Special Bryant Planning Commission Meeting

Date: March 24, 2025 - **Time:** 6:00 PM

1. Hawkins Valley Phase 1 - Preliminary Plat

GNE response to comments drawn in red

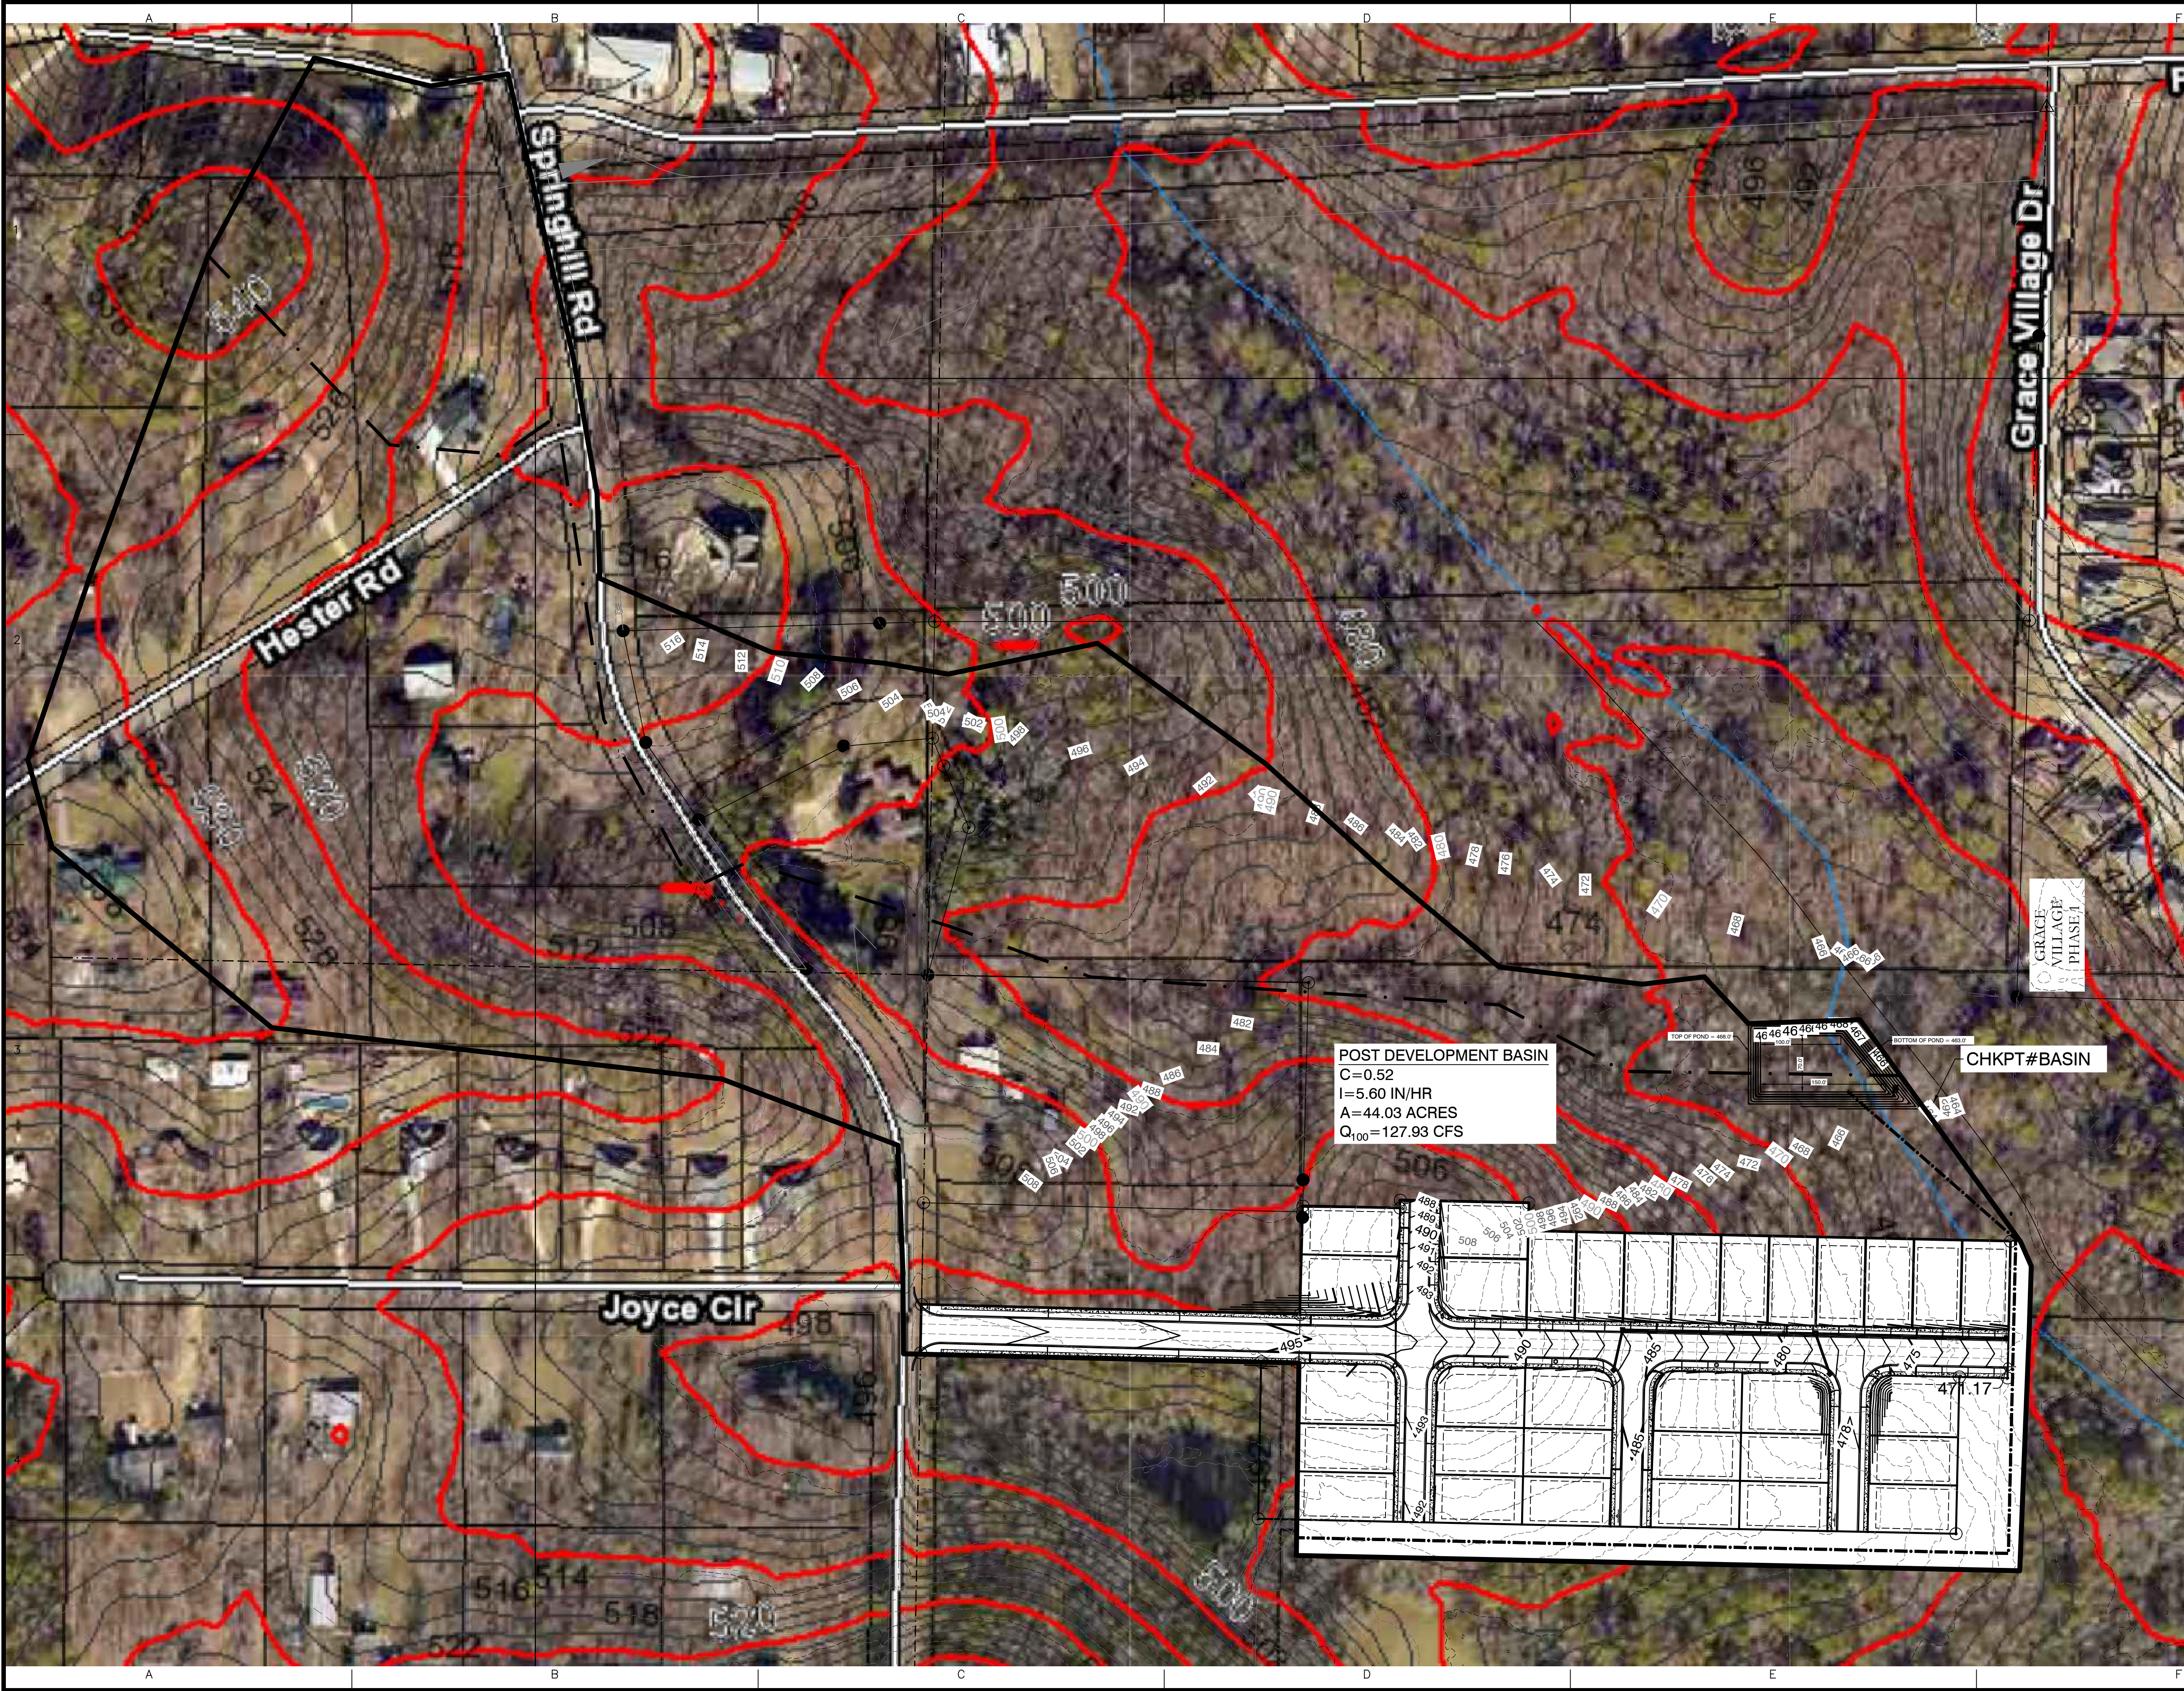
3. Page 9 – what basins is this based upon – see smaller basins / comments on page 22
4. Pages 11 & 12 – verify drainage basins SEE BELOW***
5. Page 13 – see comments on plan sheet PIPE SLOPES, SIZES, DITCH DETAILS, AND WEIR DETAILS ADDED. SEE PAGE 26 & 27.

*** WE AGREE WITH THE BASINS. HOWEVER, WE DIDN'T CHANGE THE BASIN TO MEET THE BRYANT DEADLINE. WE WOULD LIKE TO ADD OUR PROJECT TO THE FEBRUARY AGENDA. ALL FLOWS ARE RELEASED TO THE CREEK TO COMPLY WITH THE BRYANT DRAINAGE CODE.

BY		DATE	REVISION	1
FOR: THOMAS DB COLINS, LTD, LLC HAWKINS VALLEY PHASE 1 SALINE COUNTY, ARKANSAS				
PRELIMINARY				
CONTENTS: INLET BASIN PLAN				
PROJECT NO:	24076			
DATE:	JAN 2025			
SHEET NO:	3.0

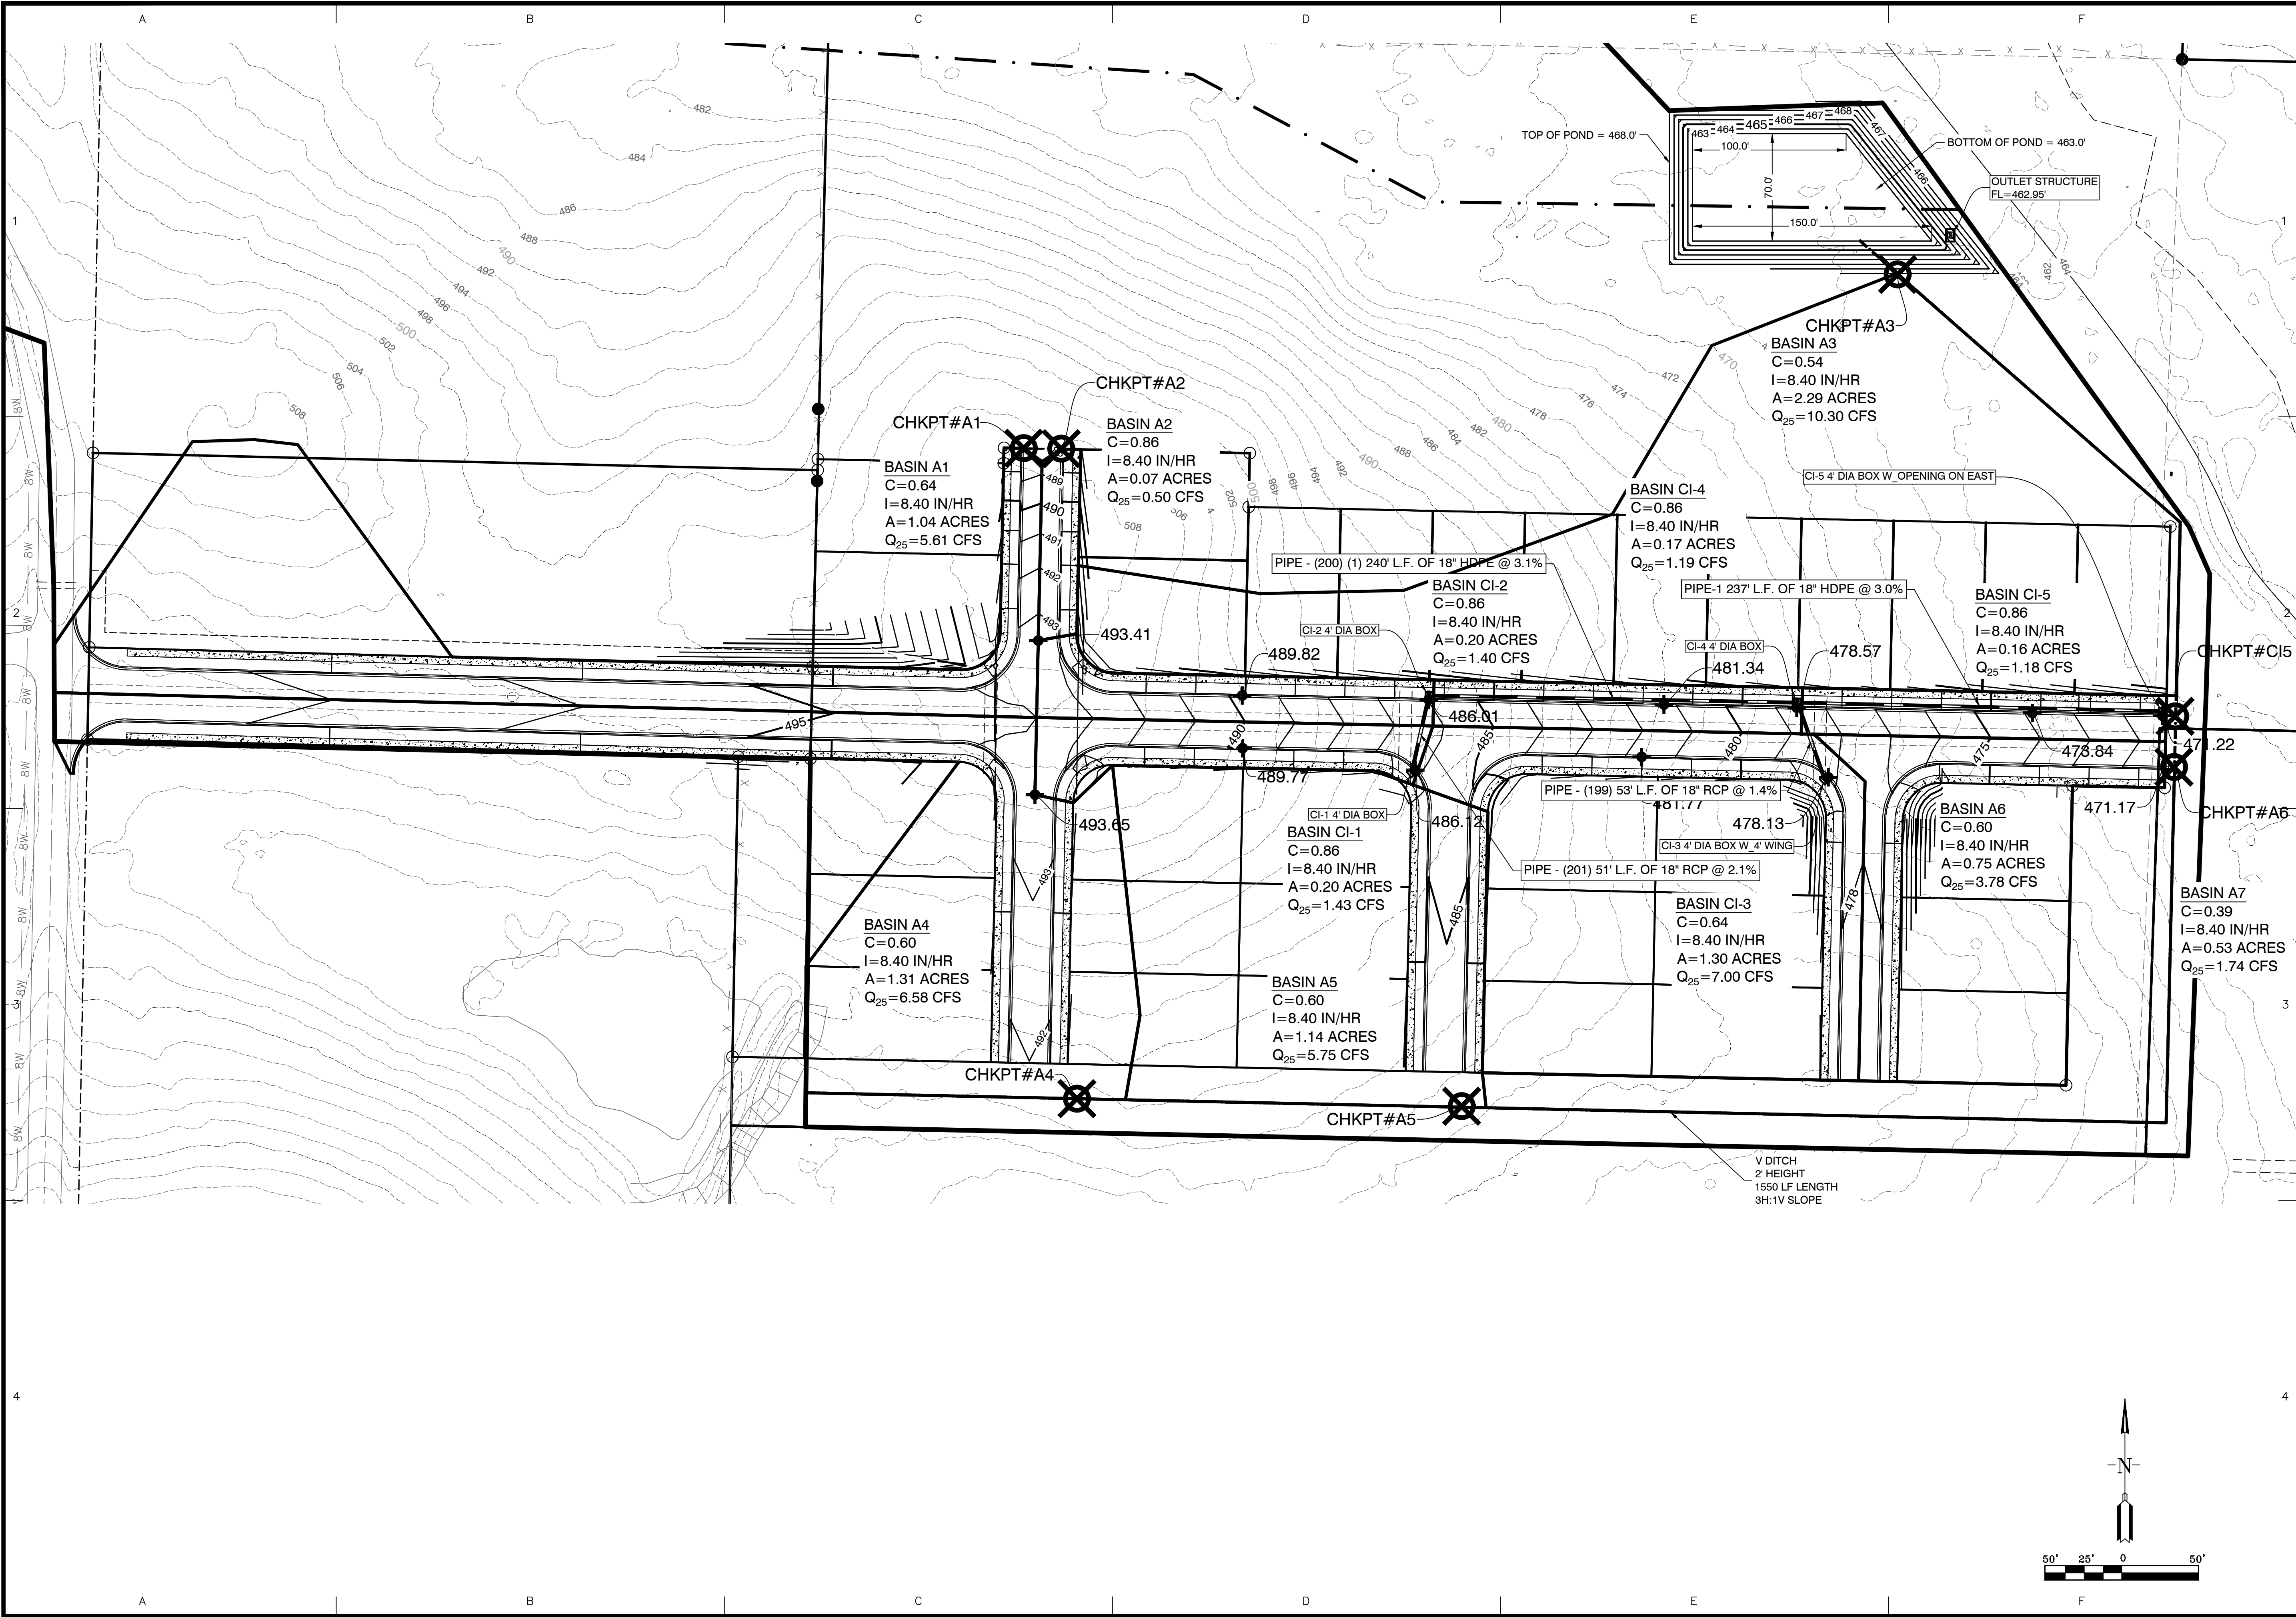
8. Page 22 – see other basins not included in the calculations.
 - a. Show pond details and layout including control structure POND DETAILS AND WEIR DETAILS ADDED SEE PAGE 26 & 27.

- b. Show pipe sizes, slopes etc PIPE SLOPES, SIZES ADDED. SEE PAGE 26
 - c. Label ditch, show details,, slope, lengths, DITCH DETAILS, SLOPE AND LENGHT ADDED AND LABELLED. SEE PAGE 26 & 27.
